FW: D2134/86 - LU-193-25-PL – Courtwick Park

Application No: LU/193/25/PL

Site Address: Court Wick Park Courtwick Lane Littlehampton BN17 7PD

Description of Works: Proposed residential development for 4 houses and associated landscaping. This application may affect the setting of a Listed Building and is in CIL Zone 2 (CIL liable as new dwellings).

Extract below from drawing 200-P10:

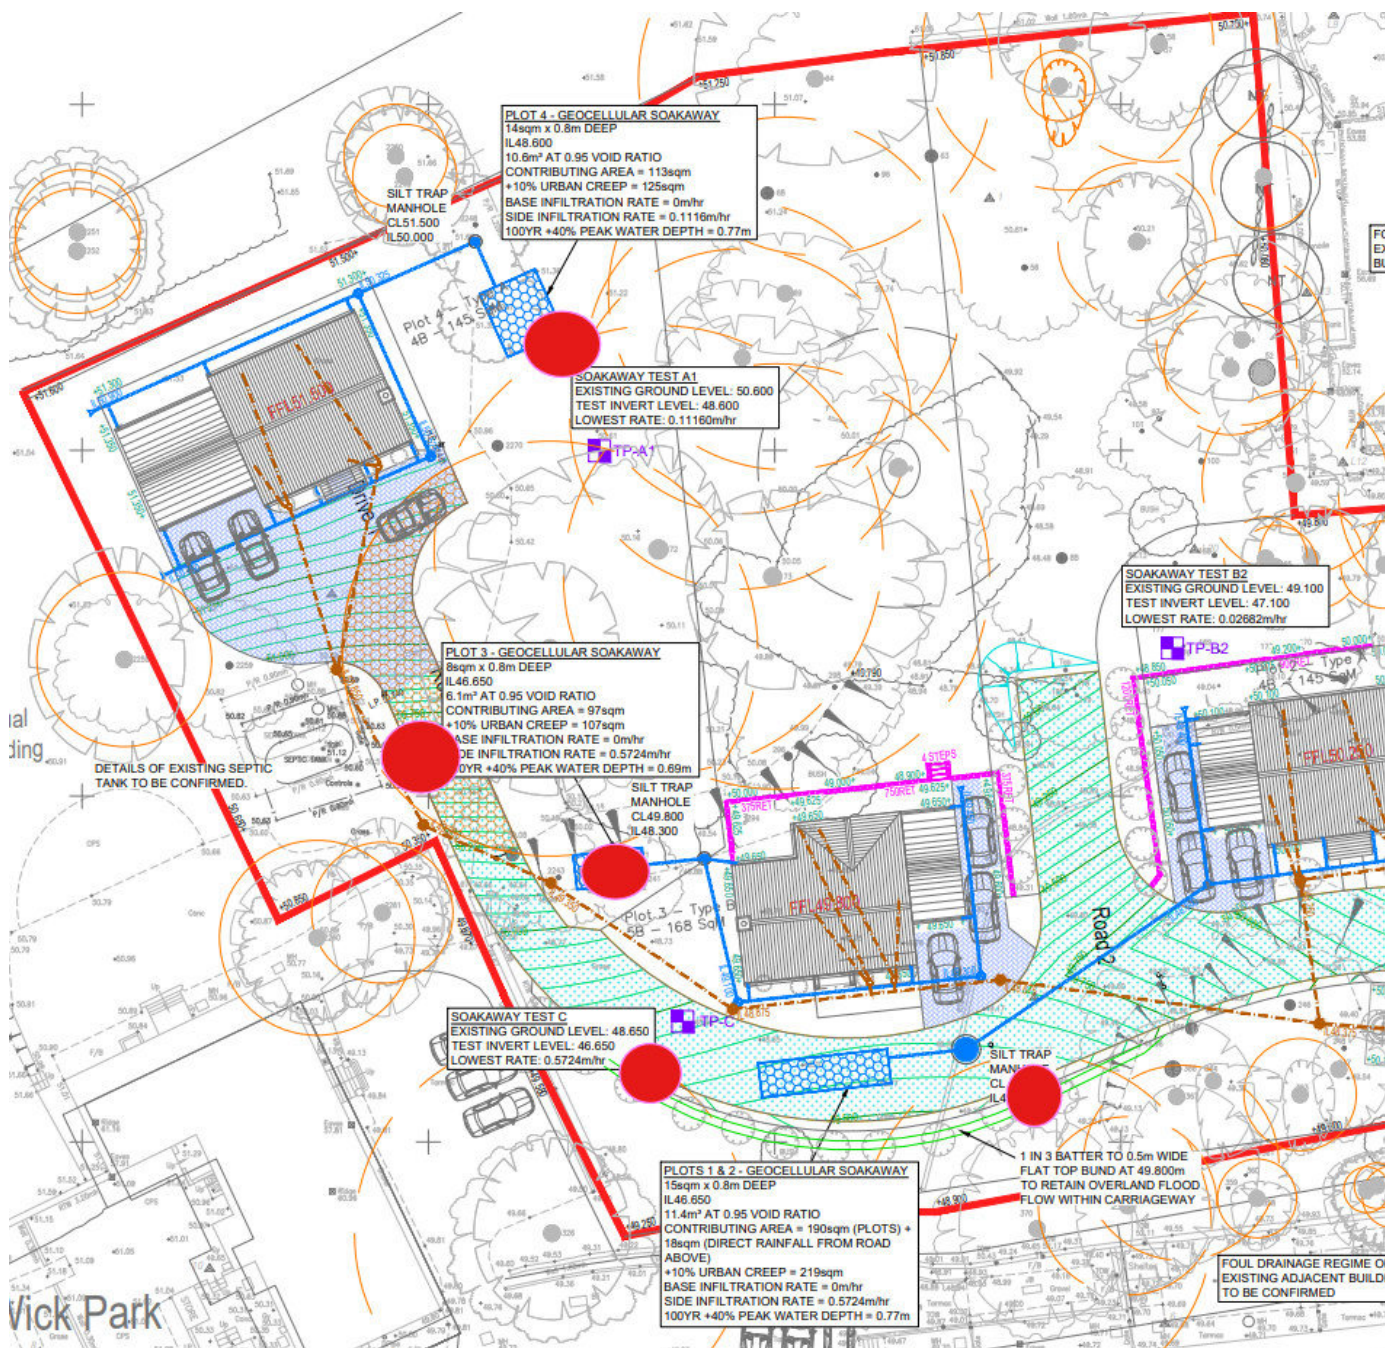
The applicant still needs to provide a formal response and evidence to all comments raised. Infiltration appears viable for this site hence not objection to std 1 (unless you feel we should here to capture the comments), however we must ensure they have modelled the worst case scenario and the size/location of each geocellular soakaway is accurate and coordinated with existing TPO trees; drawing 200-P10 shows there are a lot of trees to consider as shown below.

- My last query is just if the engineer could identify the areas where conflicts with trees/landscaping are a concern so that this can be relayed and considered by the Tree Officer/Planners. If the conflicts are broadly all over the place (given how much planting is on site) then I can understand, but in terms of a RFR, I expect harms to TPO trees would be the main concern so if there is a particular concern there, that would be helpful to know.

- There may be an issue with plot 4 soakaway if it gets larger
- There may be an issue with plot 3 soakaway if it gets larger
- There are 3 larger trees where the 'orange' conflicts with the road footprint. Some areas are shown to be 'cellweb' but not all. These need to be checked as they may affect the 'road elevation' and 'permeable pavement' storage.
